DSOX4022A-01

S E R V I C E N O T E

4000 X-Series Scopes

A replacement of the power supply cover is needed when the cabinet assembly is replaced.

New revision cabinet assembly (54709-64401)

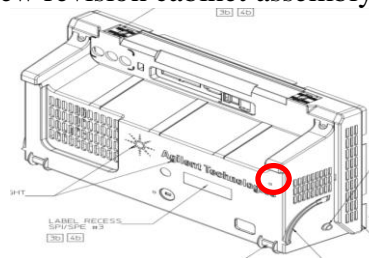
If the cabinet assembly requires a replacement, also replace the power supply cover in order to become compatible with the new revision of cabinet assembly and become compatible with zipper pouch attachment.

1. If the cabinet assembly (54709-64401) needs to be replaced, check if it is the old revision or the new revision
 - a. Old revision has 3 screw holes
 - b. New revision has 4 screw holes

2. If the cabinet assembly is the new revision, proceed with repair as normal
3. If the cabinet assembly is the old revision
 - a. Replace the power supply cover (54695-00103) with new revision
 - b. Replace cabinet assembly as usual (54709-64401)
 - c. Insert screw (0515-0380) into the new screw hole on the cabinet assembly (circled below)
